# 1982 - 1993 Corvette: Service Bulletin: Buzzing Noise at Idle

**Subject:** BUZZING NOISE AT IDLE (INSTALL PRESSURE REGULATOR VALVE)

**Bulletin Number:** 93-29-7A

Figure 1

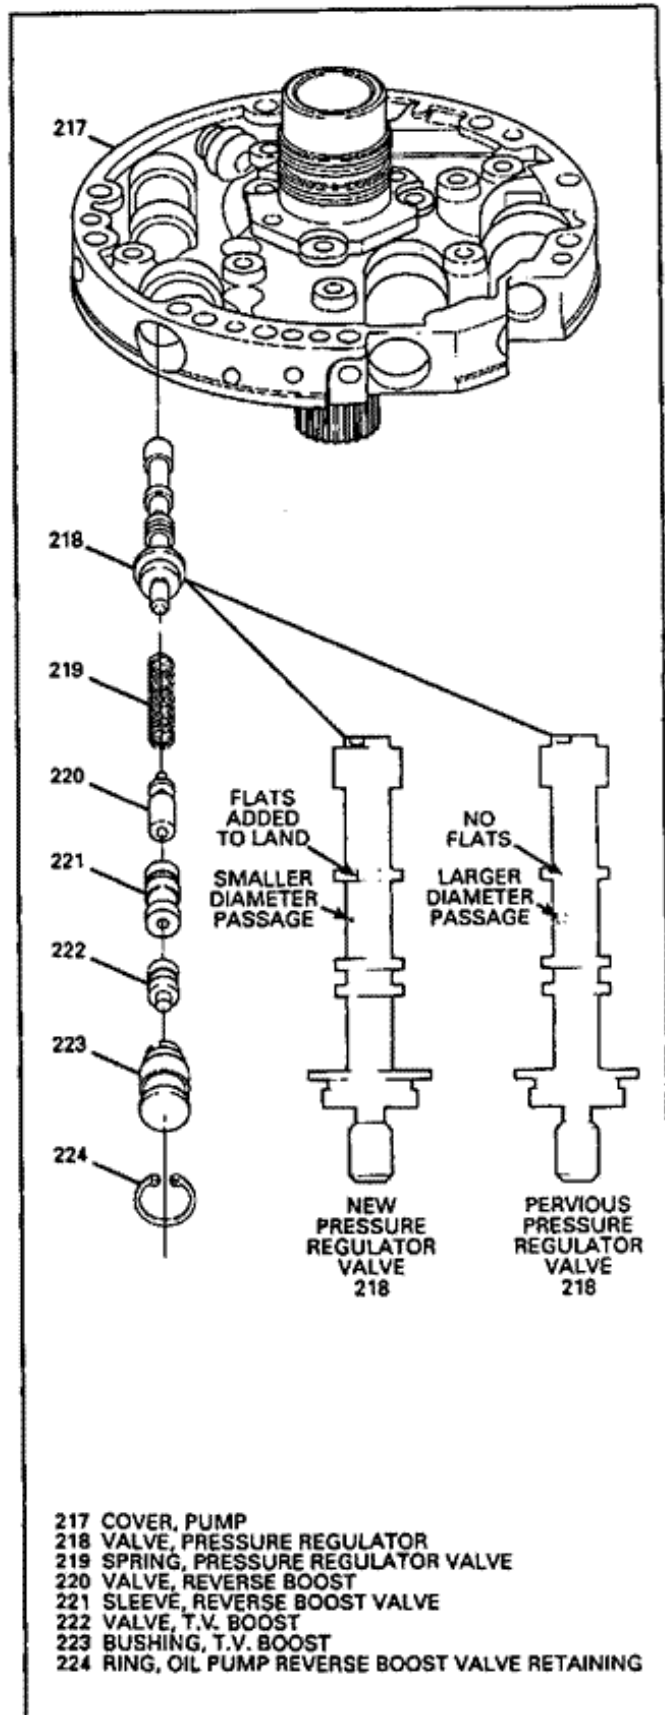
Some 1982-1993 vehicles equipped with a HYDRA-MATIC 4L60 transmission may have a buzzing noise coming from the transmission when the vehicle is at idle. The buzzing noise may be noticed more when the vehicle is in reverse at idle.

The buzzing noise may be a result of pressure regulator valve oscillating due to oil pressure instability at lower idle RPM.

A new pressure regulator valve (III. 218) has been made which will improve the oil pressure stability at lower RPM.

-----  
Valve, Pressure Regulator (III. 218) 8684048
